# Access Compliance Report

## Public Rights-of-Way

Intersection ID: 6384	Main Street: TOM_SADLER_RD	Cross Street: KINGSWAY_CR	Location:	E
ADA ID: E5CB8EA2A034	Ramp Type: Perp	Initial Pass/Fail: Fail	Overall Compliance: No	Severity Score: 13.75
Codes/Mitigation Info/Possible Solution		Field Measurements/Component Compliance

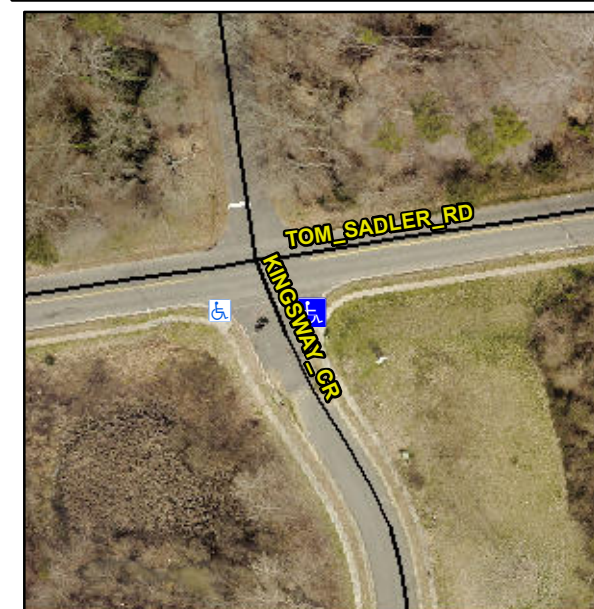
**Not Found, R304.2.2, R304.5.3**

Compliance	Description	Data	Compliance	Description	Data
N/A	Ramp Length (in)	50.5	No	Ramp Slope (%)	11.3
Yes	Ramp Width (in)	48.0	No	Ramp XSlope (%)	4.9
N/A	Flare Type LT	N/A	N/A	Flare Type RT	N/A
N/A	Flare Slope LT (%)	N/A	N/A	Flare Slope RT (%)	N/A
N/A	Flare Traversable LT?	N/A	N/A	Flare Traversable RT?	N/A
N/A	Landing Length (in)	N/A	N/A	DWS Provided?	N/A
N/A	Landing Width (in)	N/A	N/A	DWS Contrast?	N/A
N/A	Landing Slope (%)	N/A	N/A	DWS Length (in)	N/A
N/A	Landing X Slope (%)	N/A	N/A	DWS Full Width?	N/A
N/A	Landing Curb? (Y/N)	N/A	N/A	DWS Offset (in)	N/A
N/A	Shared Landing?	N/A			
N/A	Gutter Ponding?	N/A	N/A	Gutter Slope (%)	N/A
N/A	Gutter Lip Ht (in)	N/A	N/A	Gutter X Slope (%)	N/A
N/A	Painted X Walk1?	No	N/A	Painted X Walk2?	N/A
	X Walk 1 Direction	To W		X Walk 2 Direction	N/A
N/A	X Walk 1 Width (in)	N/A	N/A	X Walk 2 Width (in)	N/A
	X Walk 1 Slope (%)	5.7		X Walk 2 Slope (%)	N/A
	X Walk 1 X Slope (%)	2.0		X Walk 2 X Slope (%)	N/A

**Remove & Replace Entire Ramp.**
